Access Compliance Report

Public Rights-of-Way

(Curb Ramps)

Intersection ID: 44207	Main Street: MOCKERNUT_DR	Cross Street: TARTARIAN_CT	Location: SE
ADA ID: 1C0EC500D523	Ramp Type: PerpDiag	Initial Pass/Fail: Fail	Overall Compliance: No
Severity Score: 22.5			
Codes/Mitigation Info/Possible Solution		Field Measurements/Component Compliance

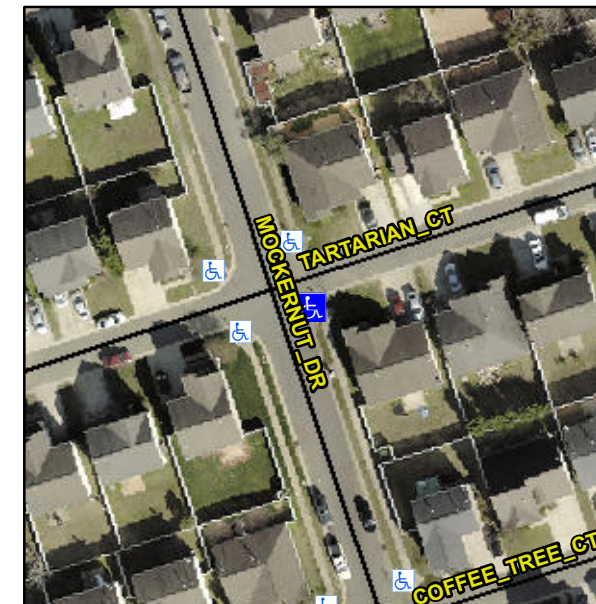
Not Found, R304.5.1, R304.2.2, R304.5.3

Compliance	Description	Data	Compliance	Description	Data
N/A	Ramp Length (in)	48.5	No	Ramp Slope (%)	10.6
No	Ramp Width (in)	47.5	No	Ramp XSlope (%)	3.2
N/A	Flare Type LT	N/A	N/A	Flare Type RT	N/A
N/A	Flare Slope LT (%)	N/A	N/A	Flare Slope RT (%)	N/A
N/A	Flare Traversable LT?	N/A	N/A	Flare Traversable RT?	N/A
N/A	Landing Length (in)	N/A	N/A	DWS Provided?	N/A
N/A	Landing Width (in)	N/A	N/A	DWS Contrast?	N/A
N/A	Landing Slope (%)	N/A	N/A	DWS Length (in)	N/A
N/A	Landing X Slope (%)	N/A	N/A	DWS Full Width?	N/A
N/A	Landing Curb? (Y/N)	N/A	N/A	DWS Offset (in)	N/A
N/A	Shared Landing?	N/A			
N/A	Gutter Ponding?	N/A	N/A	Gutter Slope (%)	N/A
N/A	Gutter Lip Ht (in)	1.0	N/A	Gutter X Slope (%)	N/A
N/A	Painted X Walk1?	No	N/A	Painted X Walk2?	No
	X Walk 1 Direction	To N		X Walk 2 Direction	To W
N/A	X Walk 1 Width (in)	N/A	N/A	X Walk 2 Width (in)	N/A
	X Walk 1 Slope (%)	0.0		X Walk 2 Slope (%)	4.0
	X Walk 1 X Slope (%)	0.6		X Walk 2 X Slope (%)	2.2

Remove & Replace Curb Ramp With Two New Directional Ramps or Equivalent.
